World Forum for Harmonization of Vehicle Regulations**Working Party on Passive Safety****Fifty-fourth session**

**Regulation No. 127 (Pedestrian safety) - Proposal for the 01 series
of amendments to Regulation No. 127****Proposal of 01 series of amendments to Regulation No. 127****Submitted by the experts from the informal working group
on global technical regulation No. 9 Phase 2***

The text reproduced below was prepared by the experts from the informal working group on global technical regulation No. 9 Phase 2 (GTR9-PH2) proposing provisions on pedestrian protection of motor vehicles. The modifications to the text of the UN Regulation are marked in bold for new or strikethrough for deleted characters.

Figure 7
Flexible lower legform impactor: Test set-up for the dynamic lower legform impactor certification test (inverse test, see paragraph 8.1.3.4.)

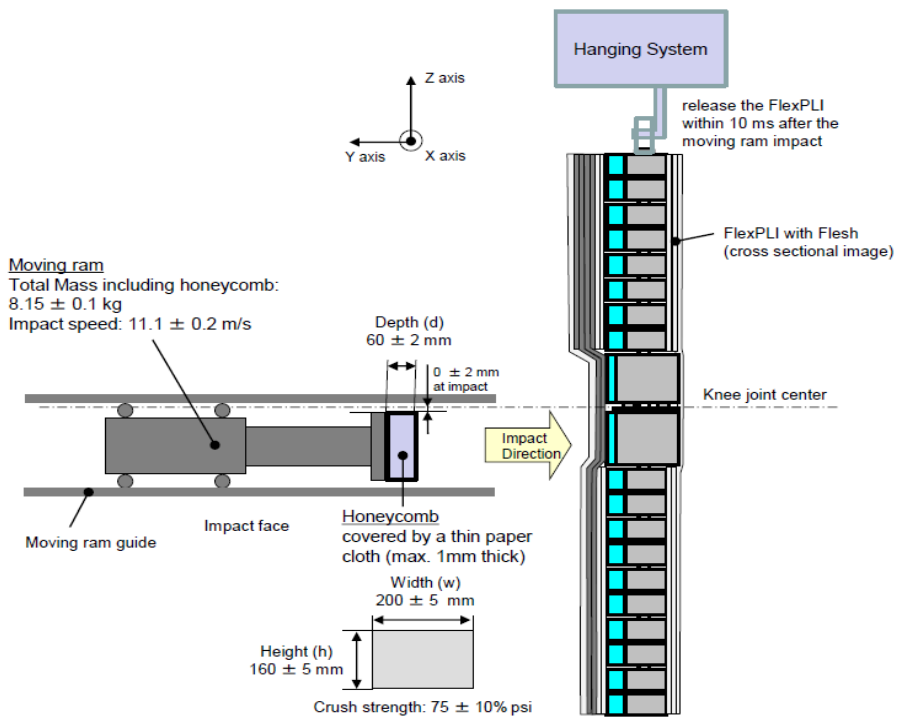
1.4.3.1. The assembled flexible lower legform impactor (with the flesh and skin) shall be hung vertically and freely suspended from a test rig as shown in Figure 7. It is then impacted by the upper edge of a linearly guided aluminium honeycomb impactor, covered by a thin paper cloth with a maximum thickness of 1 mm, at an impact speed of 11.1 ± 0.2 m/s. The

1.4.3.3. The upper edge of the honeycomb face shall be in line with the rigid plate of the linearly guided impactor. At the time of first contact, the upper edge of the honeycomb shall be in line with the knee joint centre line within a vertical tolerance of ± 2 mm.
